Plan Commission Meeting – April 15, 2015
Agenda Item 3

Amberley Woods Commercial Development
Evaluation of Revised Site Plan Based on Previously Recommended Conditions of Approval

**EVALUATION OF REVISED SITE PLAN
Amberley Woods Commercial Development**

TO:	Chairman Ley and Members of the Plan Commission
DATE:	April 15, 2015
FROM:	Catherine Czerniak, Director of Community Development
SUBJECT:	Evaluation of Revised Site Plan Based on Previously Established Conditions of Approval

Drawing Name
SITE PLAN

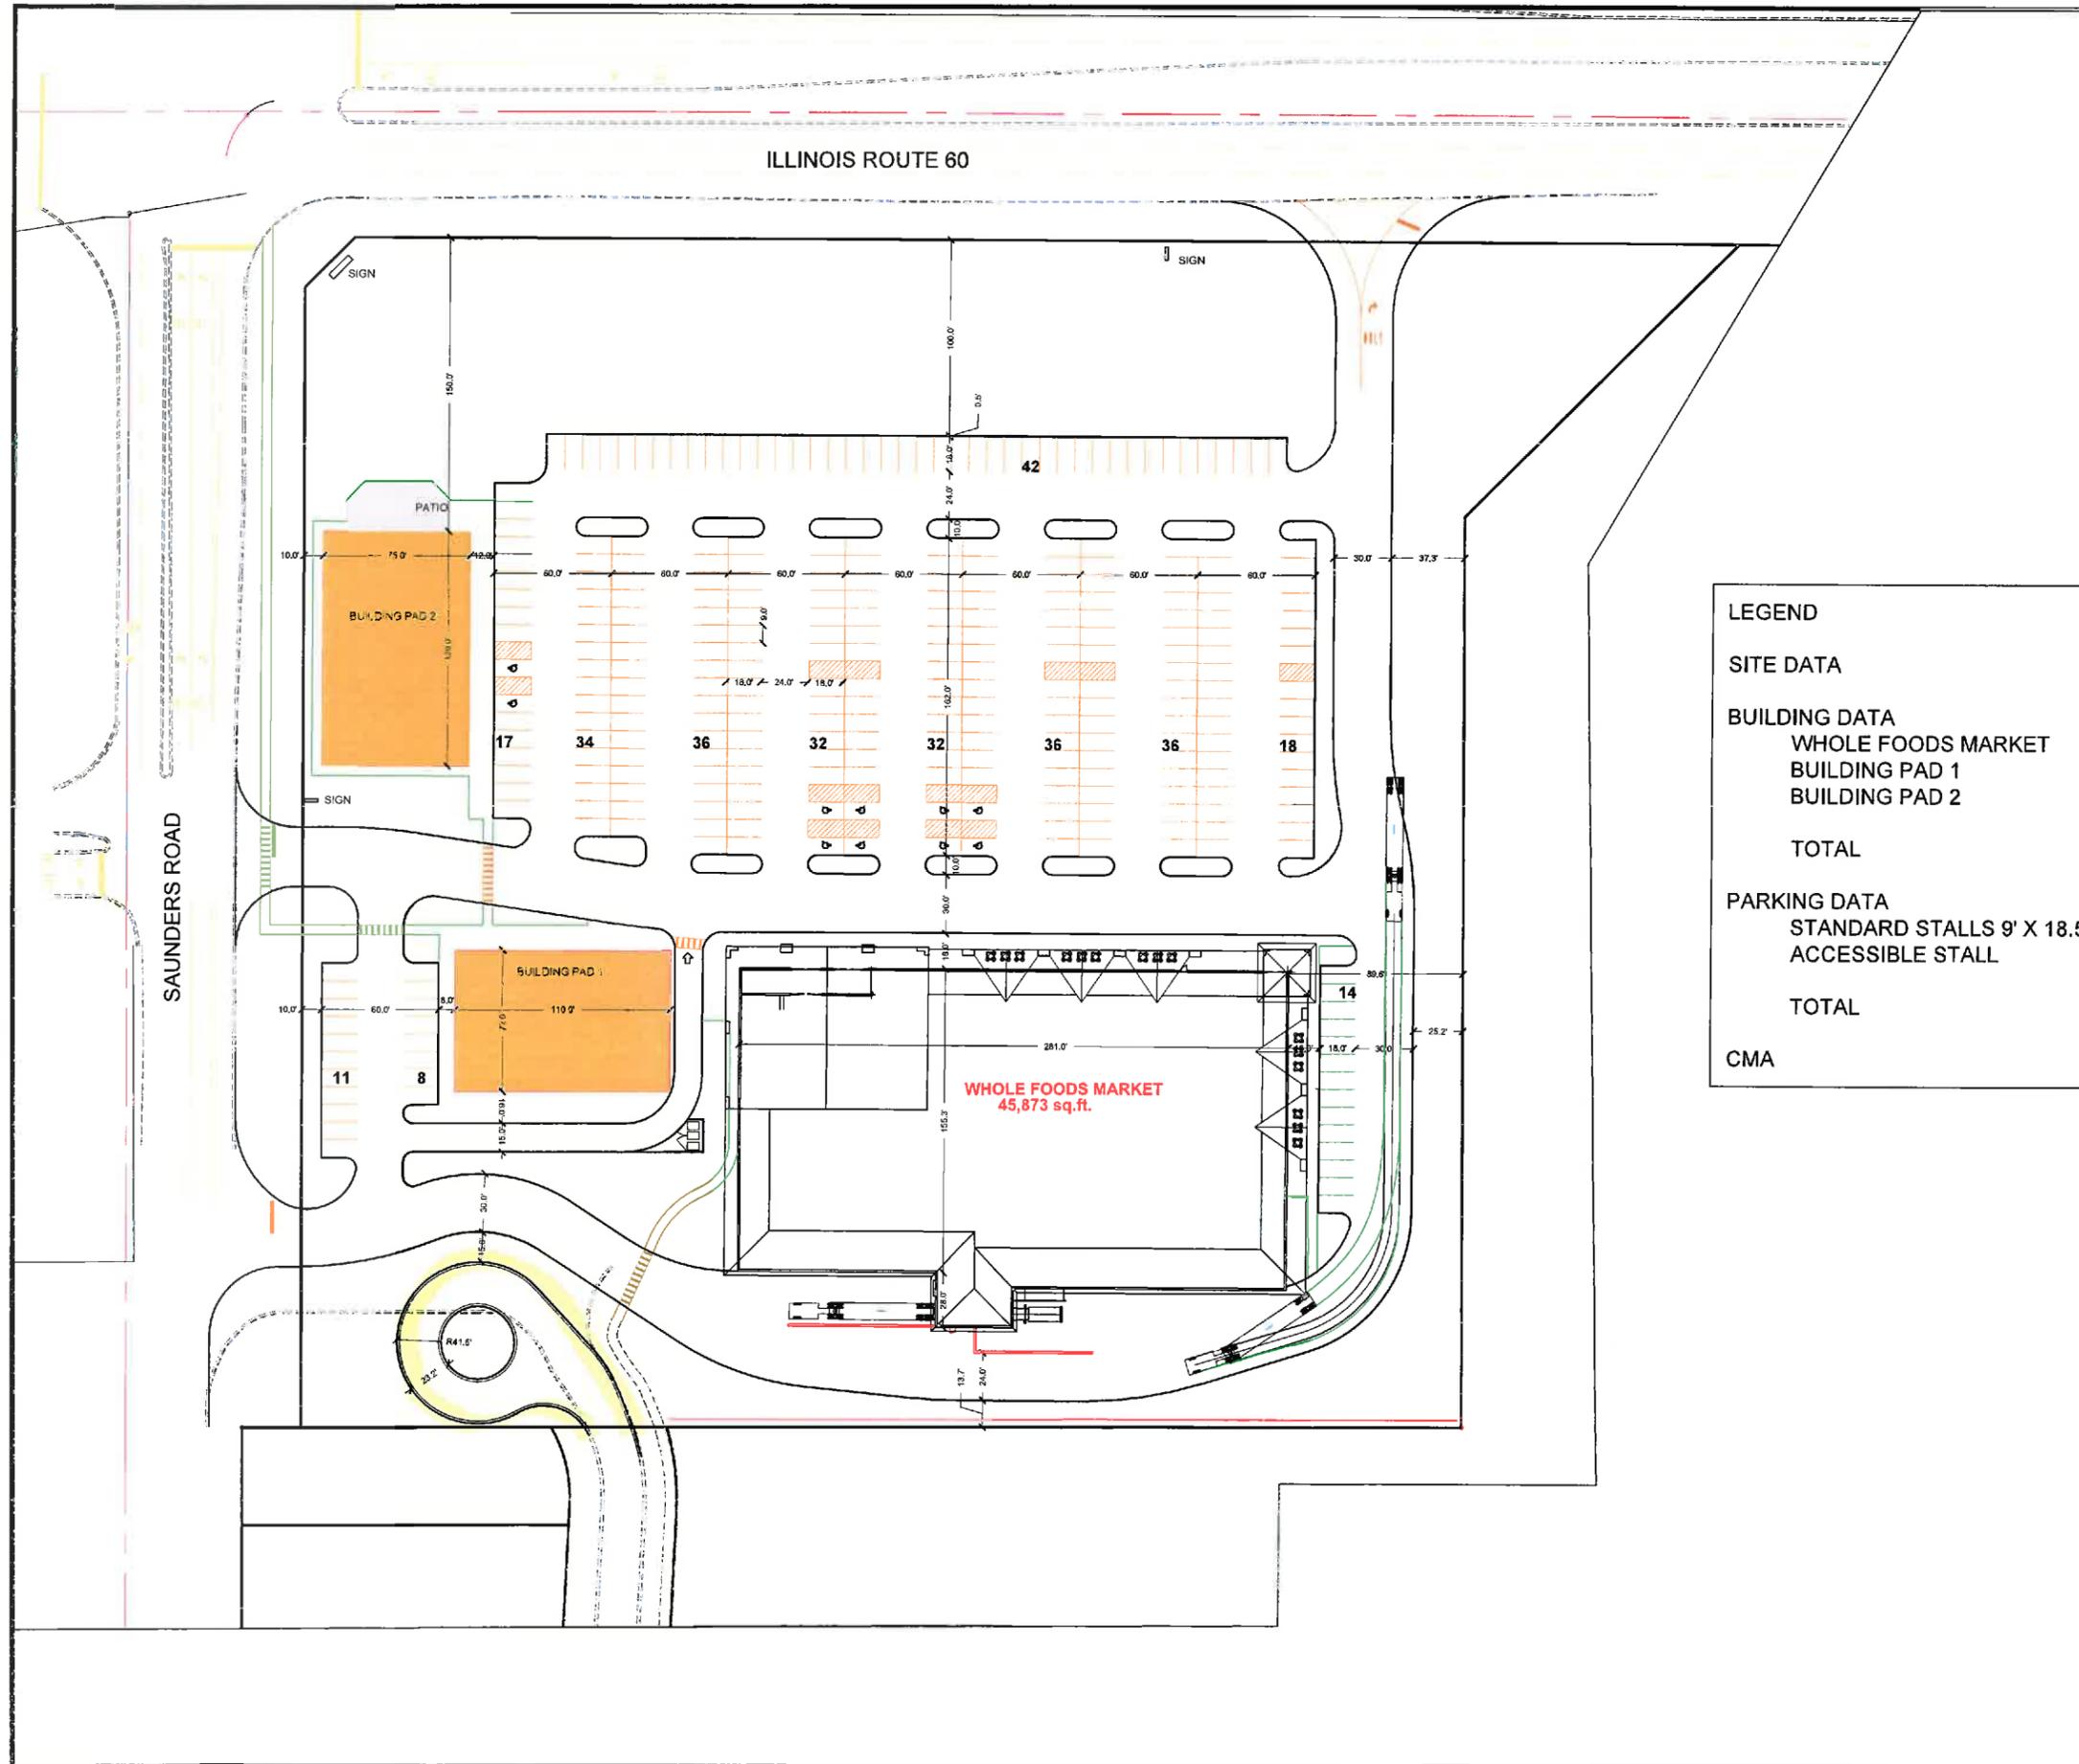
Evaluation: This condition is satisfied and the original setbacks from the north property line approved for the Amberley Woods overall development are met. The two buildings closest to Route 60 have been eliminated from the plan. Three buildings, rather than five, are now proposed. The building closest to Route 60 is setback 150' from the property line. The parking lot is setback 100' from the north property line, exceeding the 75' requirement established in this condition.

Evaluation: This condition is satisfied and the original setbacks from the south property line approved for the Amberley Woods overall development are met. The main mass of the building is setback more than 65' from the south property line. A small portion of the building, the area where trucks will unload, is set back 50' from the south property line. At the closest point, the service drive is located just under 14' from the south property line for a short distance. The service drive then curves away from the property line to a maximum setback distance of approximately 60'.

Evaluation: This condition is generally satisfied. Building Pad 2 is setback 10' from the west property line near Saunders Road. A small parking area, located to the south of Building Pad 2 is located 10' from the west property line. In discussions of the previous plan, encroachment into the setback along Saunders Road was not a significant concern. Staff encouraged the petitioner to increase the setback on the east side of the development, adjacent to the Amberley Woods Condominium development, at the expense of moving closer to the west property line. The current plan does not propose any encroachment of buildings or parking areas into the parkway along Saunders Road.

Evaluation: This condition is satisfied. There is only one building on the revised plan that extends toward the east side of the property. The bank building previously proposed for the northeast corner of the property has been eliminated from the plan. The grocery store building is located 89' away from the east property line, significantly exceeding the 50' setback requirement.

The service drive, which enters the site from Route 60, is located 37' from the property line on the northern portion of the site, closest to the existing condominium building, and gets as close as 25' to the east property line on the south half of the site.
